August 4, 2008

SUBJECT: Response to April 4th, 2008 IDWR memo from John Lindgren to Aaron Marshal *Injury Assessment of Groundwater Impacts for Proposed Water Rights Transfer Comore Loma Subdivision*

Figure 1. Groundwater elevation contours (blue lines) and inferred flow directions (blue arrows) based on actual field measurements. The heavy black line represents the model boundary, which is setup as a no-flow condition.

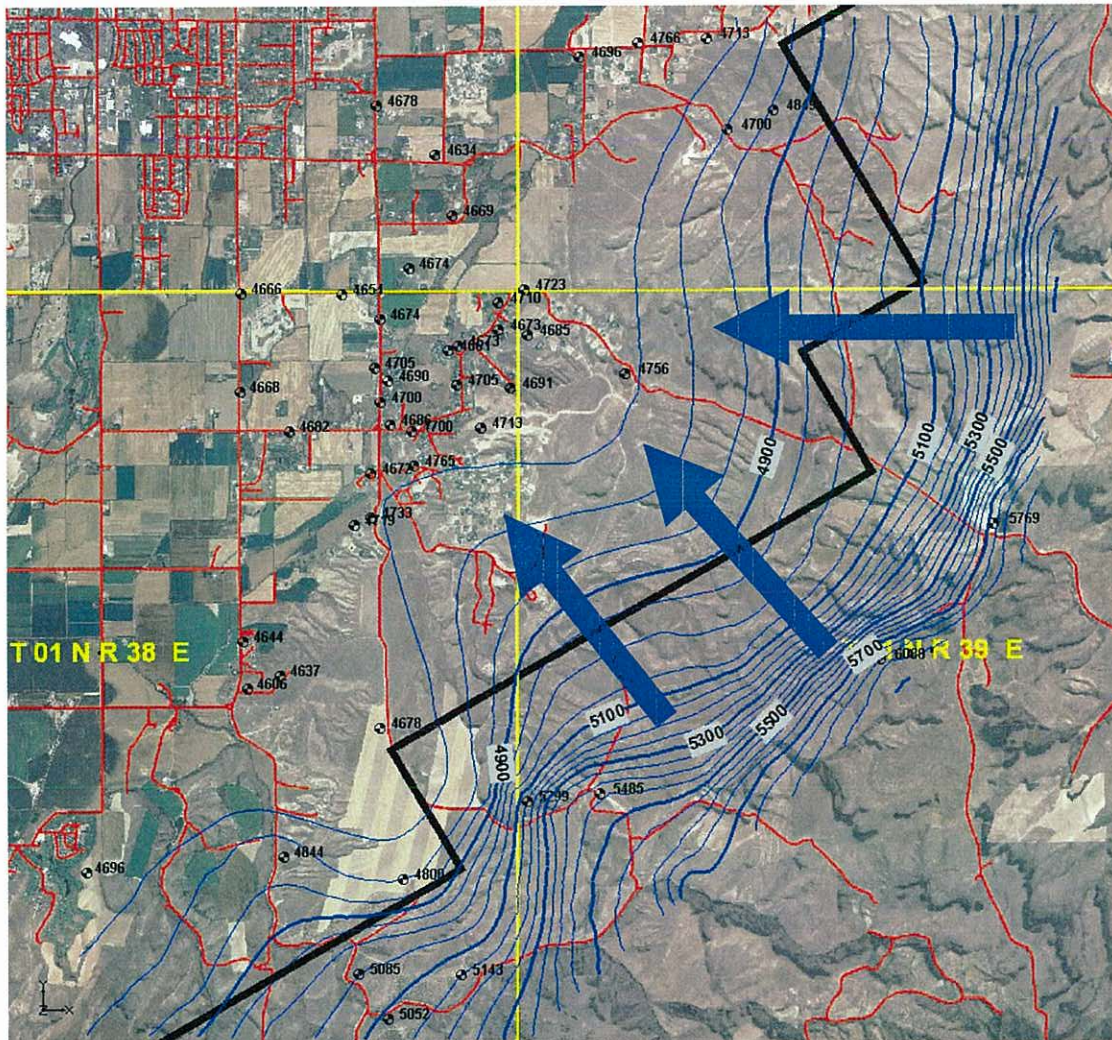
We show in our report that the water table in the vicinity of the Comore Loma property, based on measured water levels in wells, flows in a northwesterly direction, which is perpendicular to the model boundary. The ESPAM predicts a southwesterly flow direction parallel to the model boundary and perpendicular to the measured groundwater flow direction. We also document how the ESPAM water table elevation is 300 feet lower than the actual water table. This miss-match between the "calibrated" ESPAM and real data indicates either a serious flaw in the model "calibration" and/or a problem with the conceptual model used to build the numerical simulation. Figure 5 shows the groundwater map of the ESPAM and the flow direction and the water table map based on well measurements.

Figure 2. Location of model cells representing specified flux into the ESPAM. Approximate location of Comore Loma shown for reference. Reprinted from IWRRRI Technical Report 06-002 (Cosgrove et al., 2006).

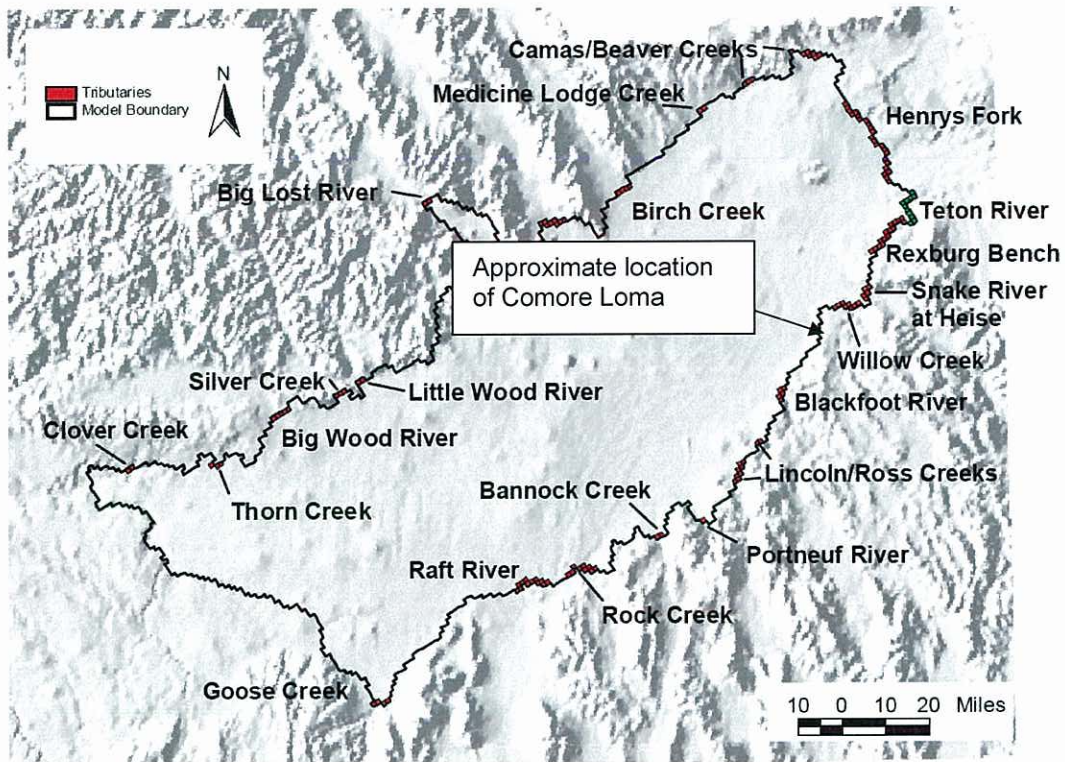
Mr. Lindgren's assertion that our report contends that the ESPAM does not include subterranean flow is true at the local scale only. We state that the ESPAM does not account for underflow from the mountain front to the east of Comore Loma, which it does not. However, we are confused as to how Mr. Lindgren construed this to mean that we said no underflow is represented anywhere in the ESPAM. It is well documented that there are specific areas at the boundaries of the model where underflow is tributary. As a matter of fact, we employed these same flux boundary conditions in our modeling runs using the ESPAM. The nearest location where underflow is specified in the ESPAM is nearly 10 miles away from Comore Loma. Figure 2 below is a reprint of Figure 22 from

IWRRI Technical Report 06-002 (Cosgrove et al., 2006), showing the locations of specified underflow. Figure 3 shows the specified flux cells near the Comore Loma property.

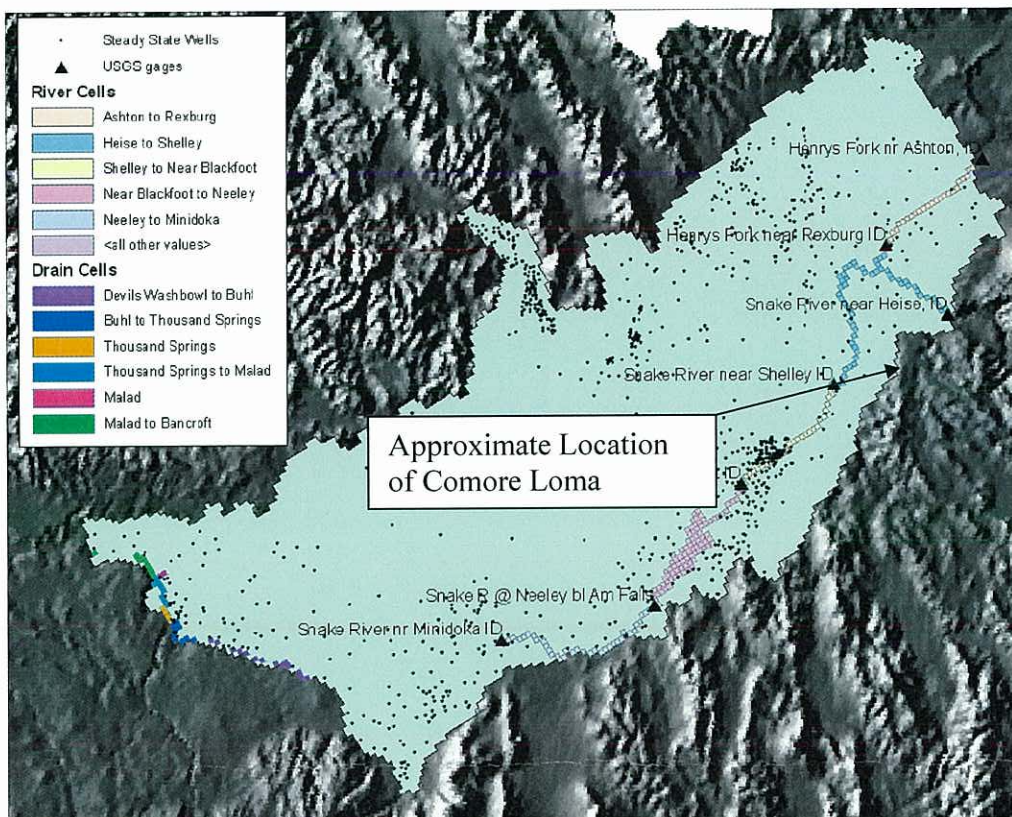
Again, Mr. Lindgren is overstating the merits of the ESPAM as a calibrated model, especially at the scale important for the Comore Loma Transfer. The ESPAM was calibrated at the scale of the model domain, some 11,000 sq miles, to water levels in about 1009 aquifer wells. This is very few wells at the scale of the aquifer and cannot possibly be rigorous enough for the purposes of the Comore Loma transfer, in fact, page 101 of the ESPAM report states "*the ESPAM is a regional model and is not intended for predictions of impacts to individual springs. A regional model is limited to replicating broad-scale heterogeneity in the physical system and cannot replicate localized heterogeneities.*" Figure 4 shows the locations of IDWR's calibration points for the steady-state version of the ESPAM (reprinted from Figure 55 in IWRRI Technical Report 06-002). The nearest calibration point is over 10 miles away from Comore Loma.

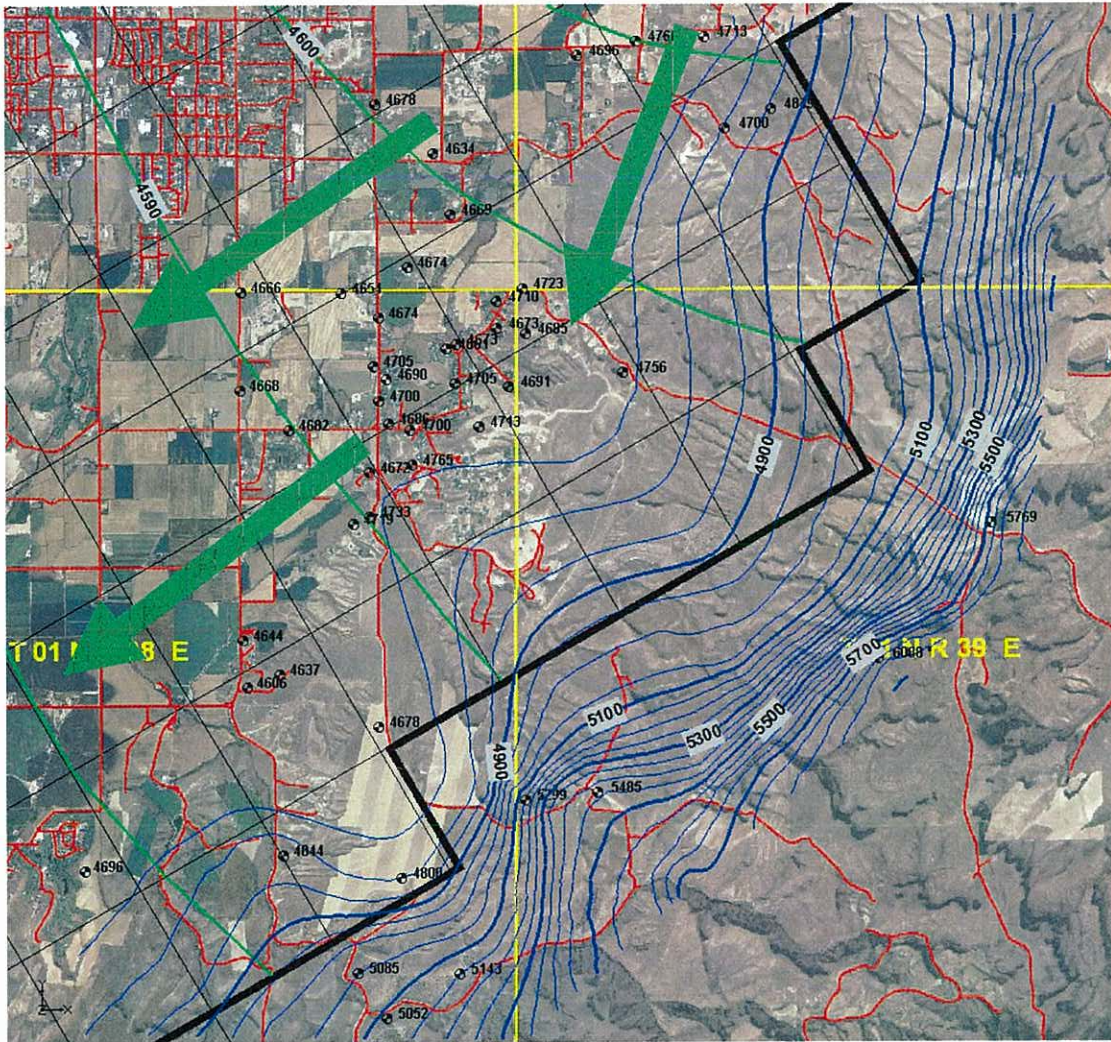
The mismatches between flow direction and water table elevation are serious and render the ESPAM nearly useless for the Comore Loma Transfer, but the problems could be corrected by simple modifications to the ESPAM. Consider Darcy's Law:
